ADDENDUM

NO. 2

PROJECT NAME: Jarrell Middle School Addition and Renovations

ADDENDUM DATE: 4, September 2018

ELECTRICAL FLOOR PLAN - SECTION 1

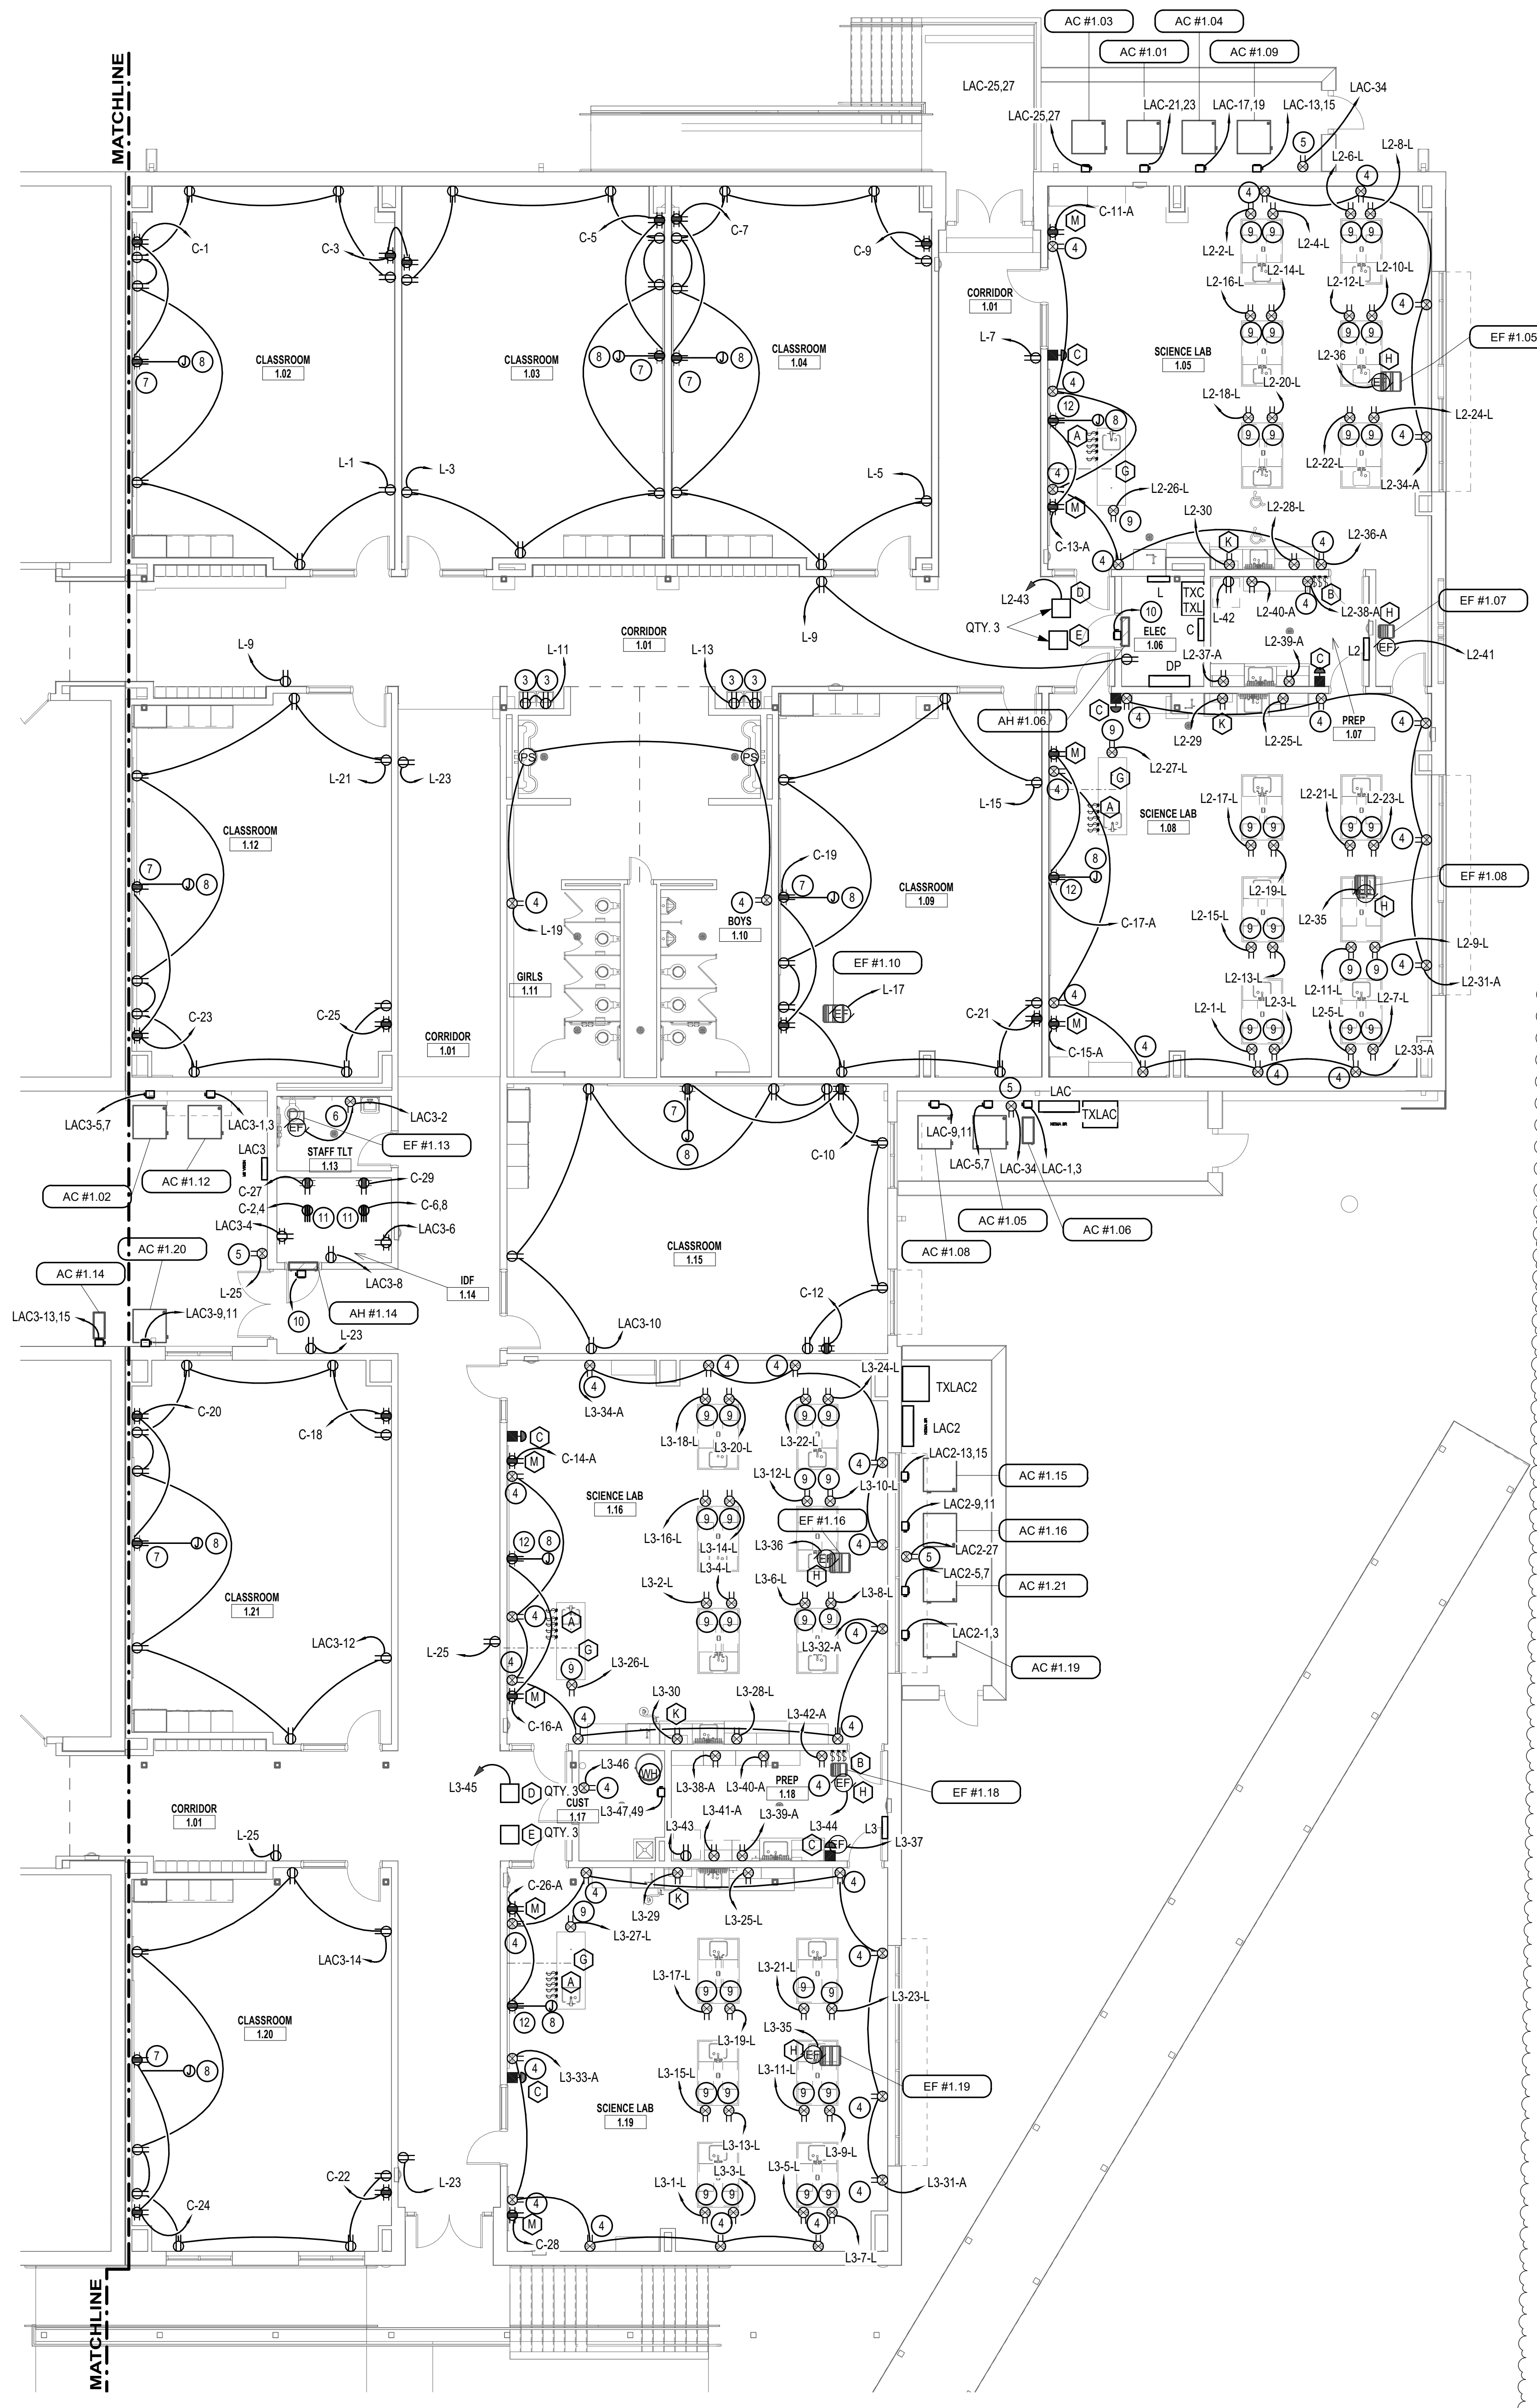
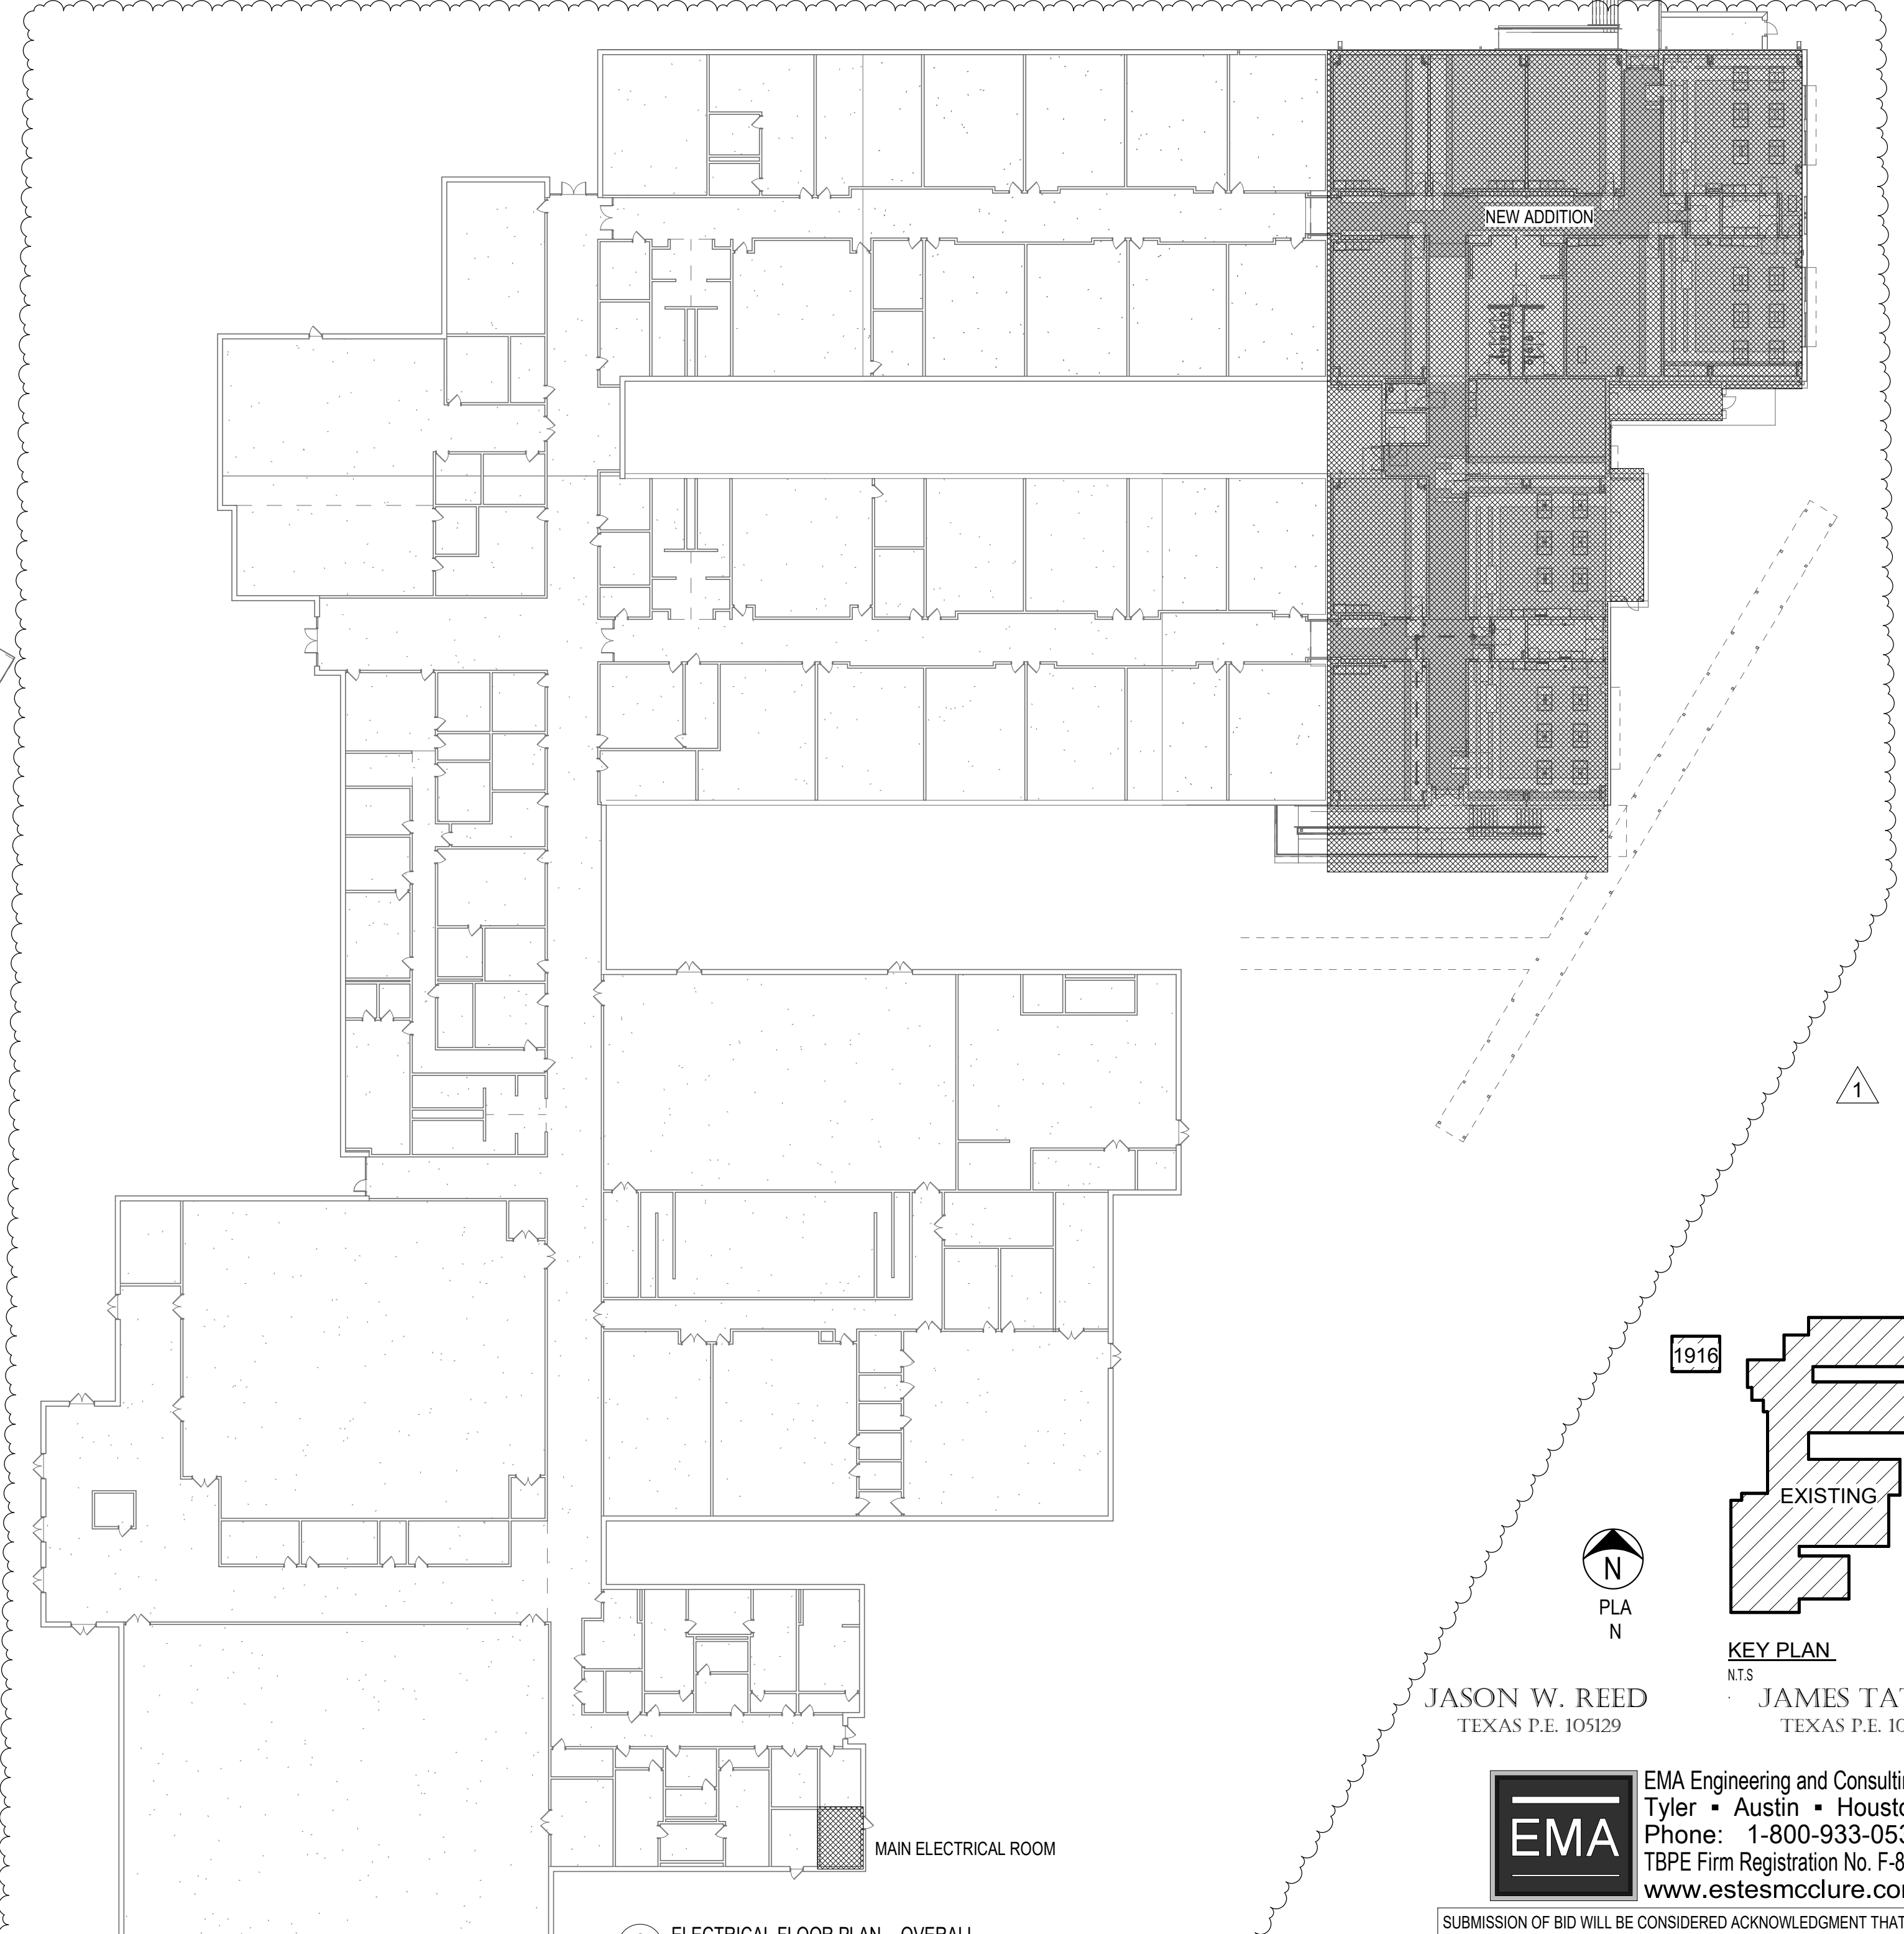
AD No 2, Elec. Item 1: To the Drawings, Sheet EP1.1, "ELECTRICAL FLOOR PLAN - SECTION 1,"

- 1) Added an overall floor plan with new addition and main electrical room highlighted.

PLUMBING FLOOR PLAN - SECTION 1

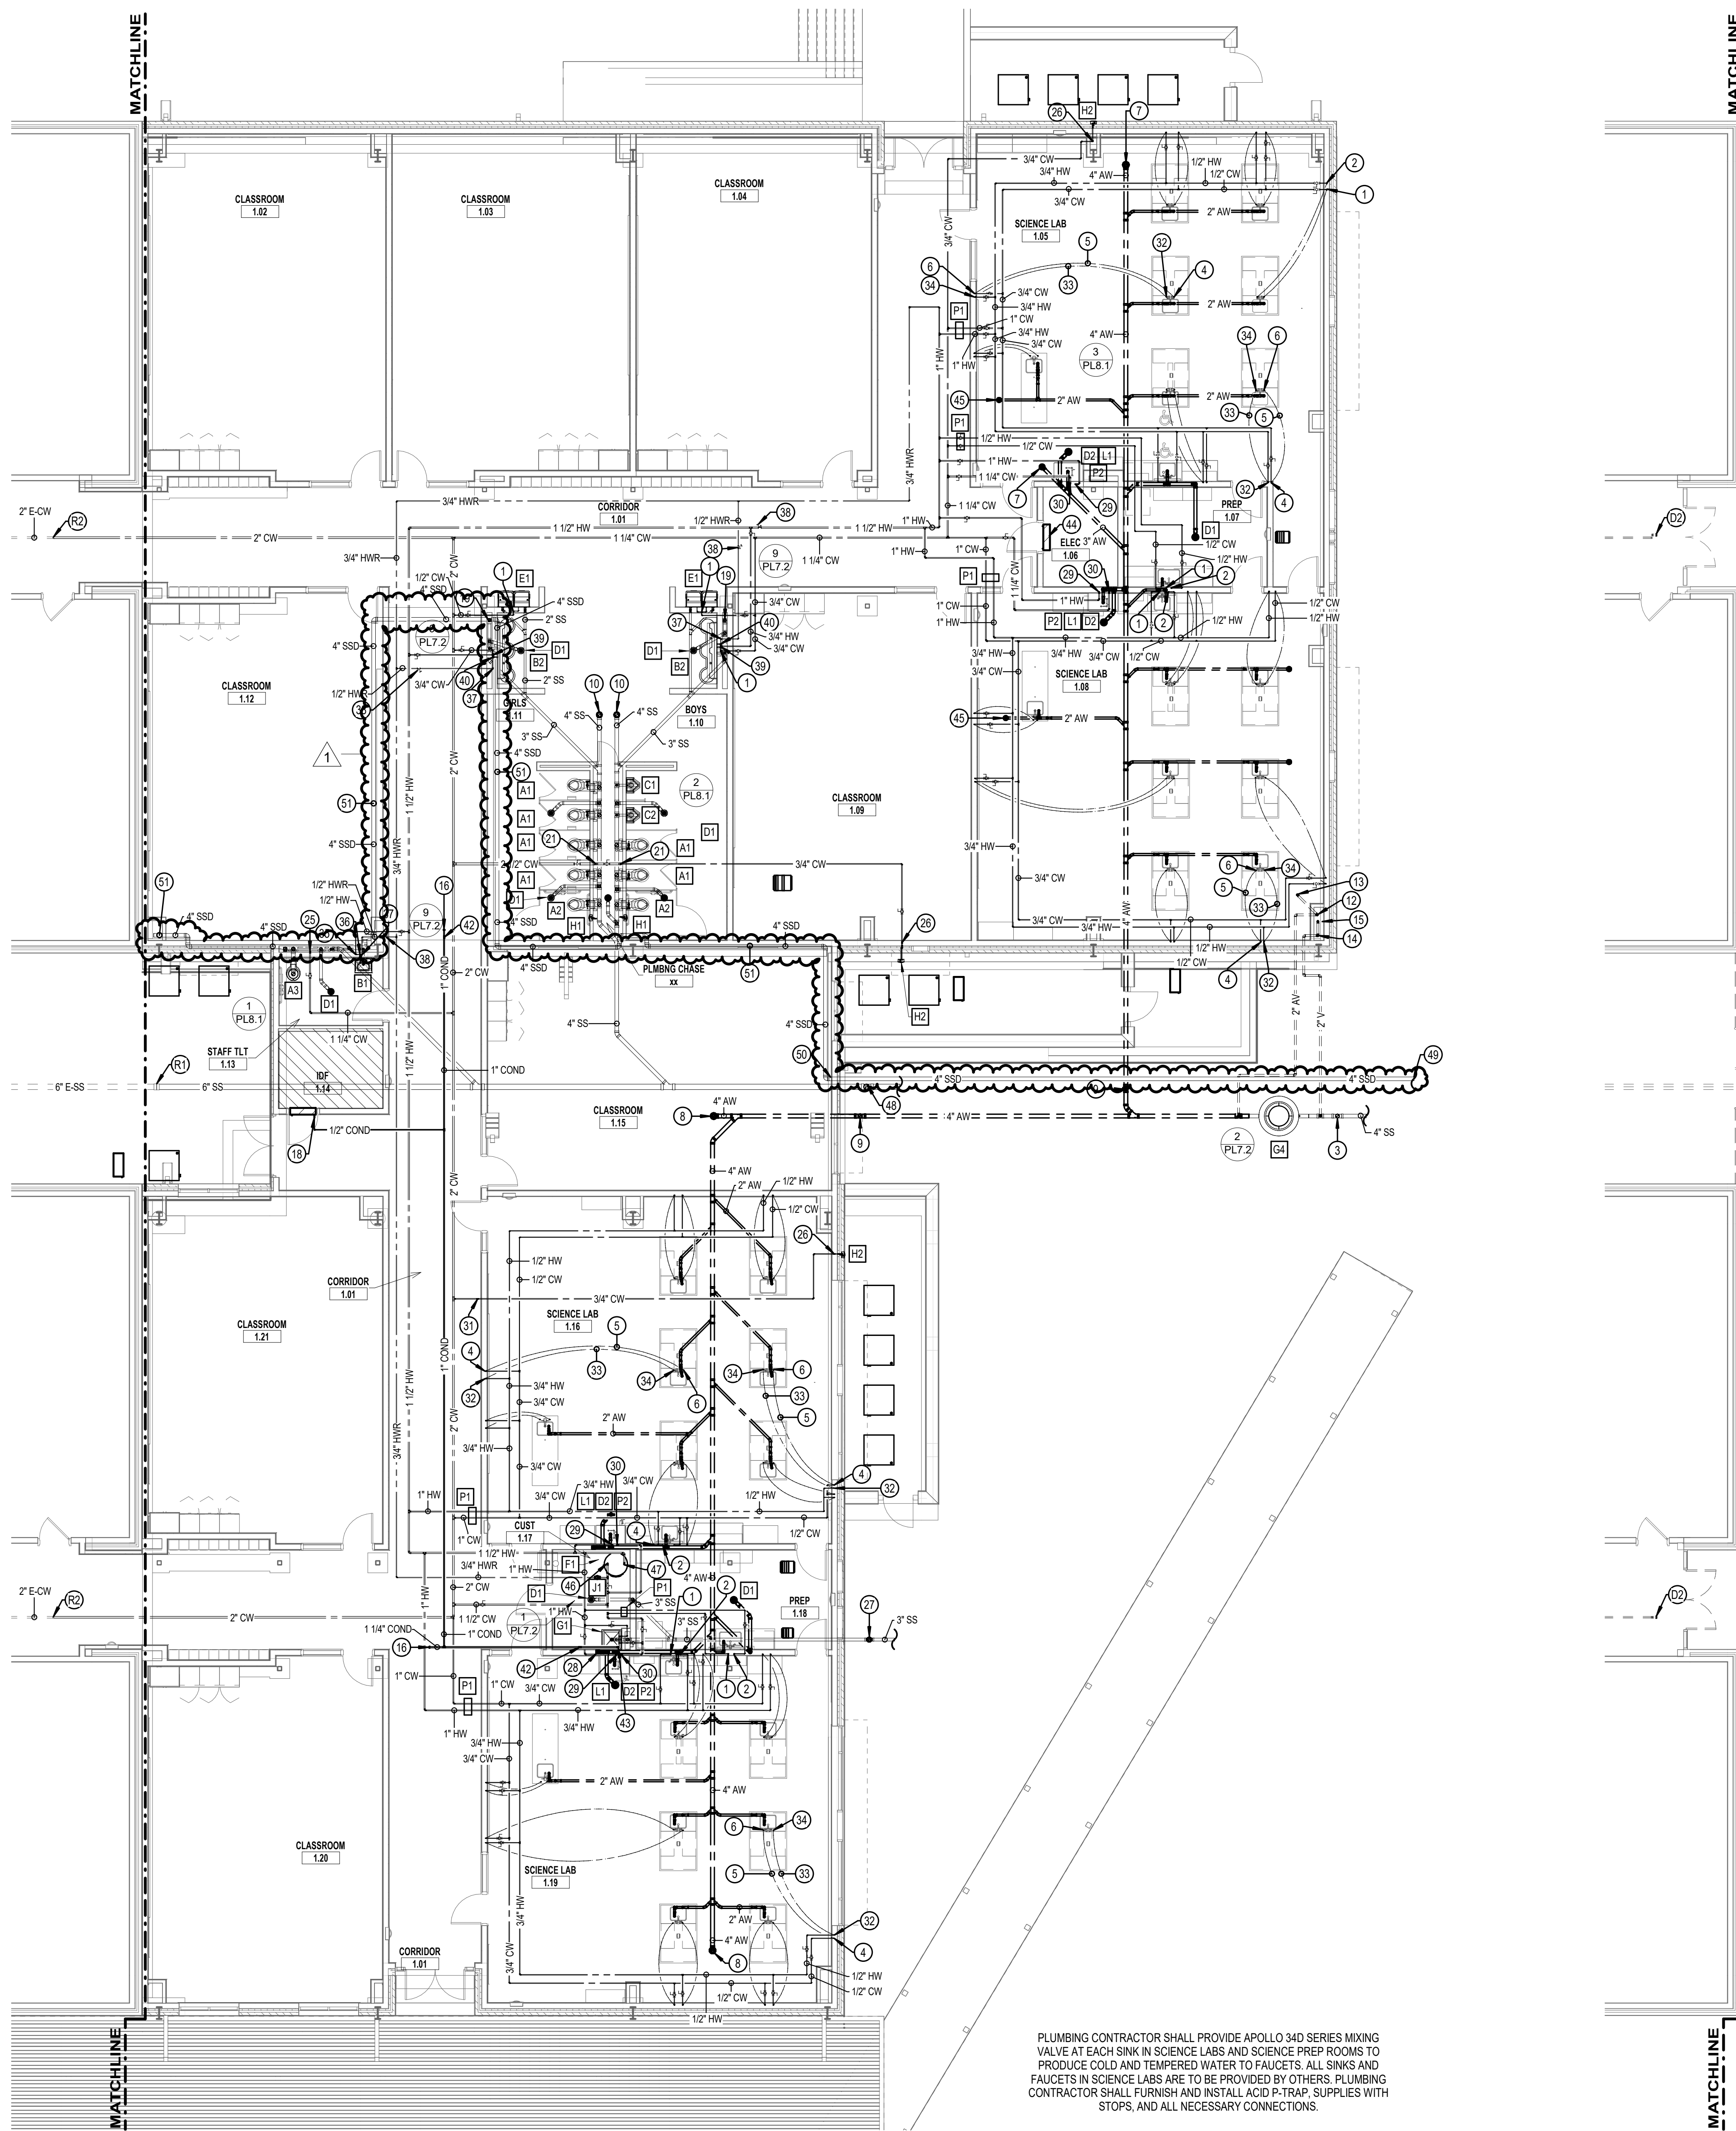
AD No 2, Plumb. Item 2: To the Drawings, Sheet PL1.1, "PLUMBING FLOOR PLAN - SECTION 1,"

- 1) Added subsoil drain, and associated piping & notes.
- 2) Removed "H3" in north section of CORRIDOR 1.01
